THE DHAMRA-CHANDBALI PORT EXPANSION PROJECT, ORISSA, INDIA

Critique of the Environmental Impact Assessment

By Dr. Paul Johnston & Dr. David Santillo Greenpeace Research Laboratories, School of Biosciences, University of Exeter May 2007

Fig.1: Map showing discrepancy between port site chosen by the EIA and the one currently being developed.

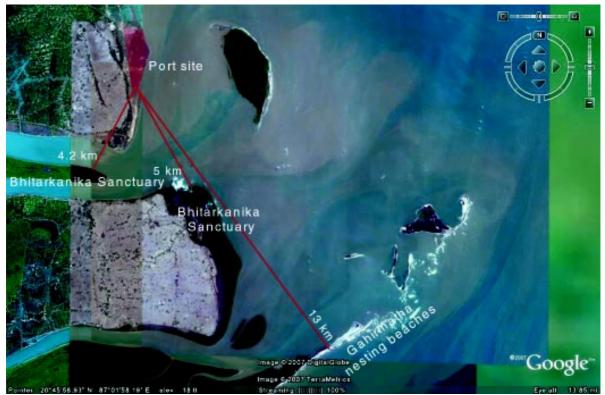
considers two options for the port's location, one on the Kanika Sands itself, and the other on the mainland, before discarding the mainland option in favour of Kanika Sands. The EIA then goes on to evaluate impacts on the basis of the port location on Kanika Sands. However, the project as it is currently being implemented locates the port on the mainland and not Kanika Sands. Such a fundamental discrepancy then calls into question the credibility of the entire EIA as a basis on which to gauge the environmental impacts of the project. (Fig 1, Pg 14)
